LOCA Mass and Energy Release Analysis

Code Applicability Report for US-APWR

SUBJECT: FINAL SAFETY EVALUATION FOR TOPICAL REPORT MUAP-07012-P AND
MUAP-07012-NP, REVISION 2 "LOCA MASS AND ENERGY RELEASE
ANALYSIS CODE APPLICABILITY REPORT FOR US-APWR"

Figure 8-1 Integral of Broken Loop SG Side Break Flow from WREFLOOD

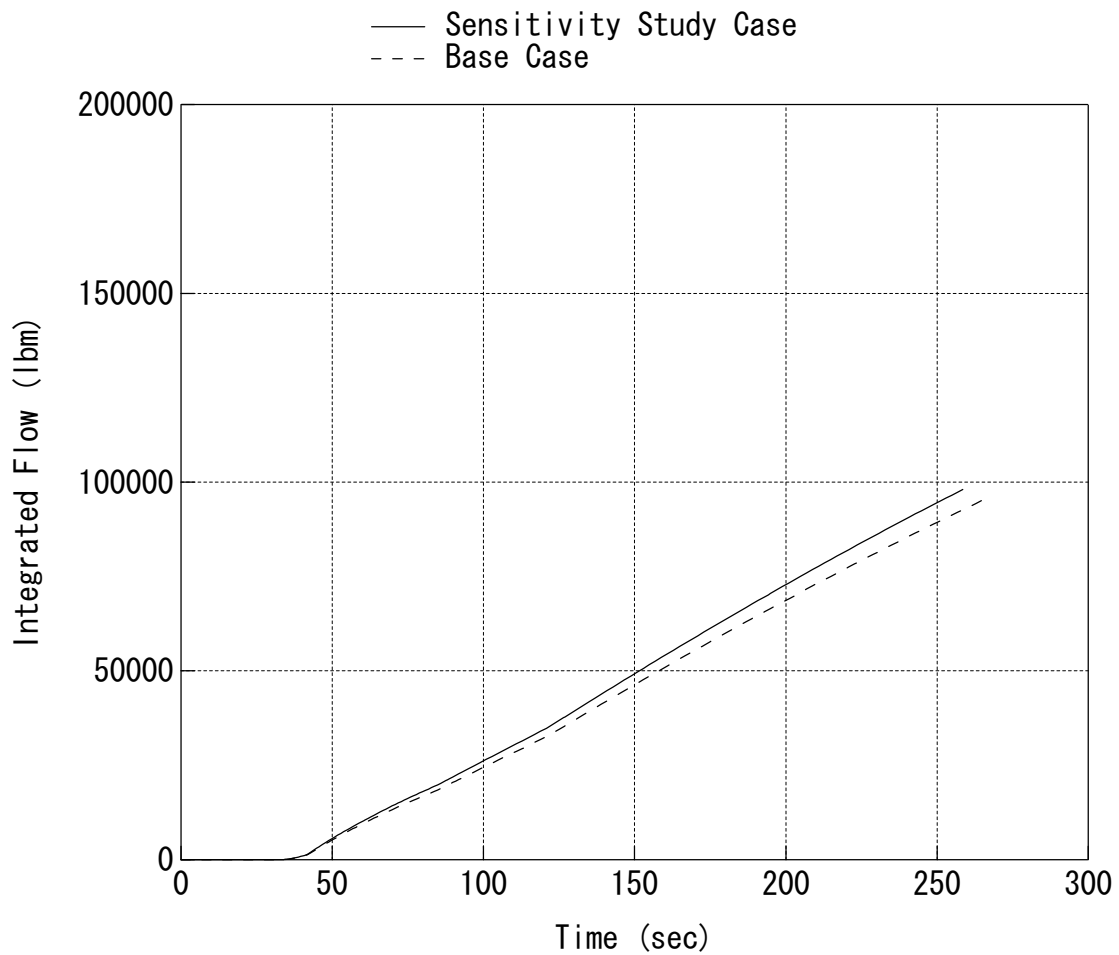
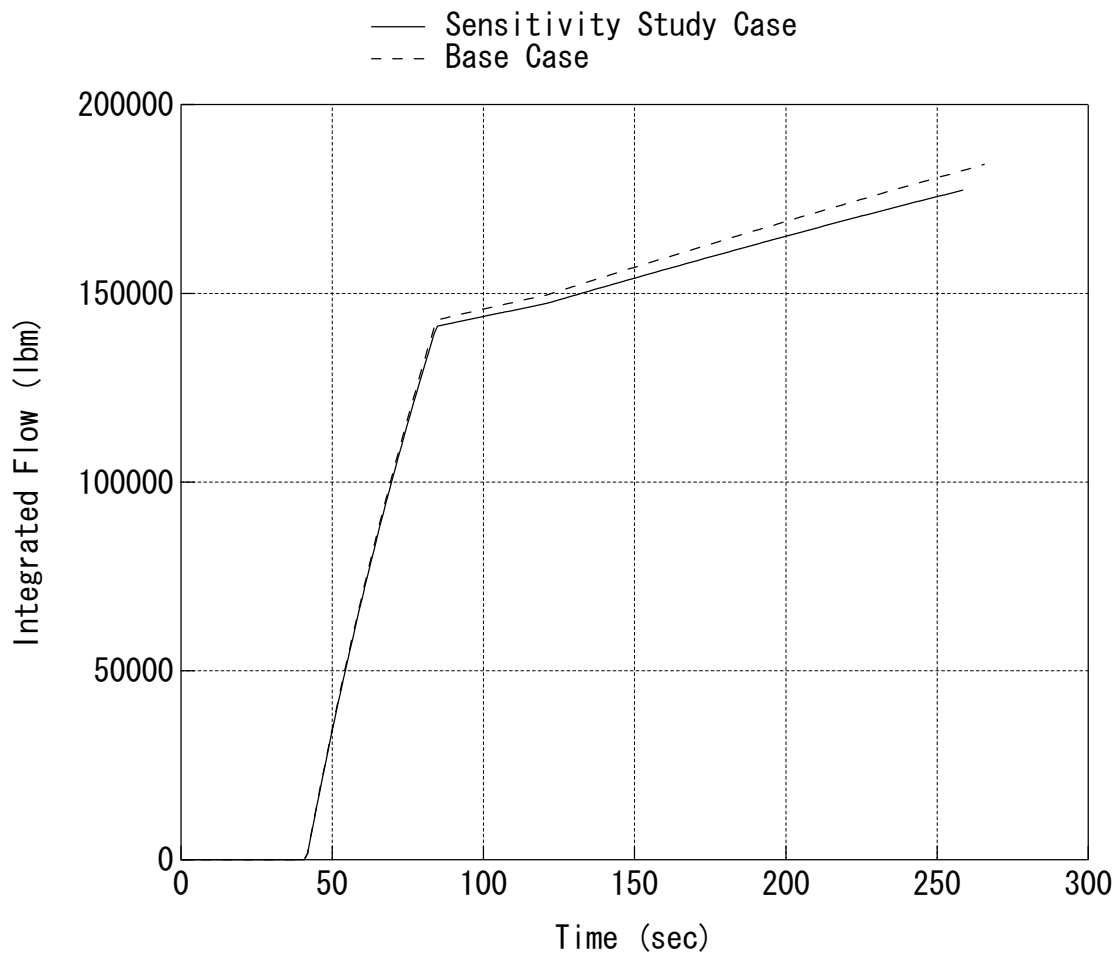
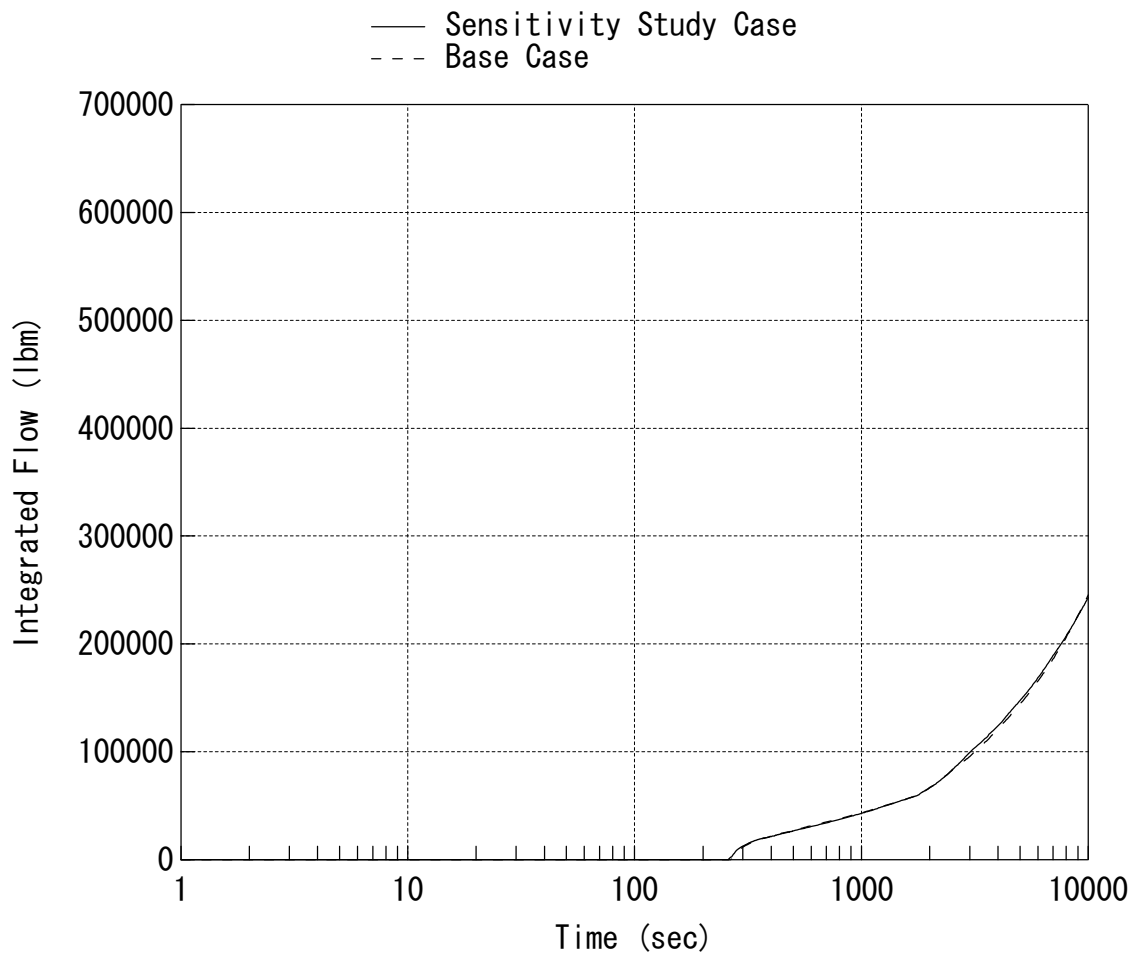
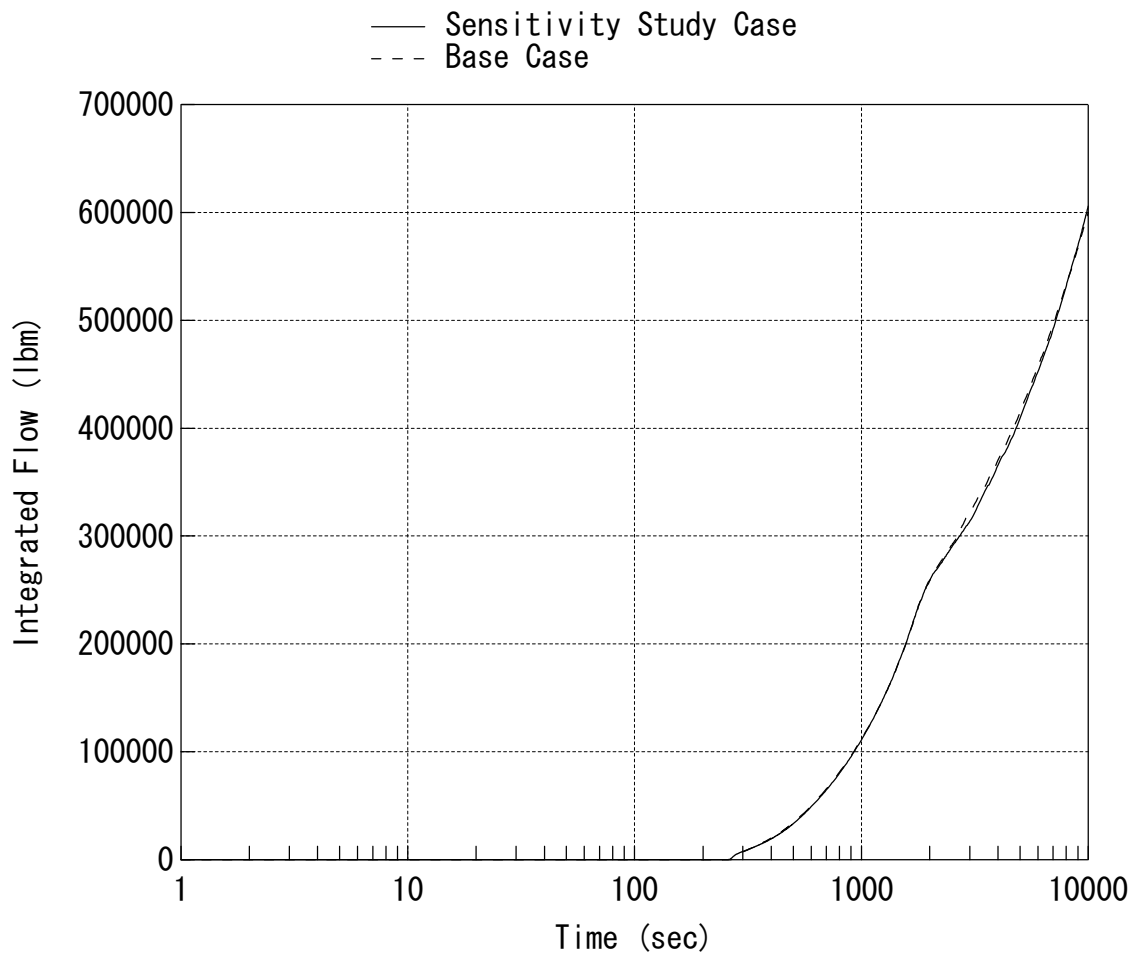
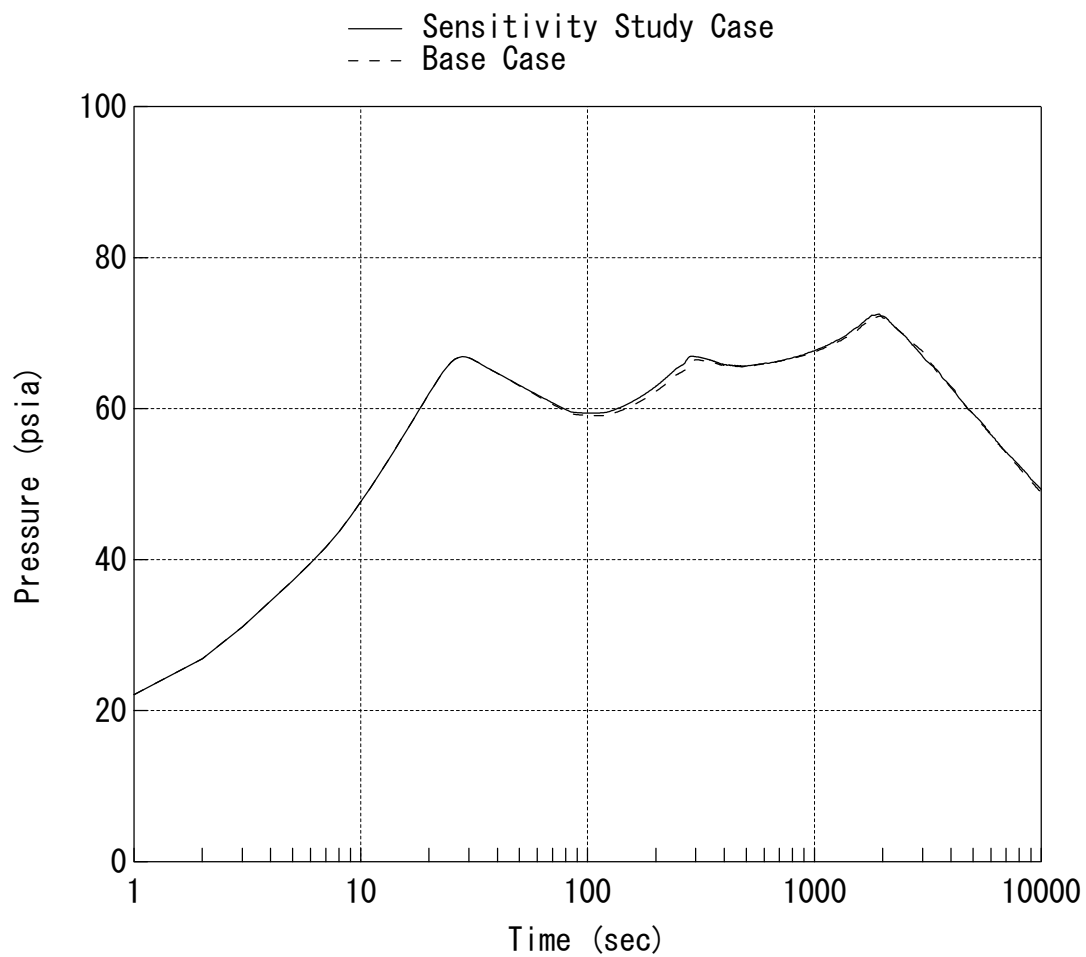
Results of the sensitivity study show slightly larger steam flow to the containment than the base case as shown in Figure 8-1 to Figure 8-4. The peak containment pressure is about 72.5 psia and is 0.3 psi higher than the base case as shown in Figure 8-5. The peak pressure is substantially lower than the design pressure. The effect of 20% lower loop resistance on the peak containment pressure is small, because most of the loop resistance is due to the RCP and piping resistance is relatively small.

This increase in the peak containment pressure due to lower primary loop resistance is small relative to the identified conservative margin in peak pressure{ } as described in the response to Items 16 and 17.
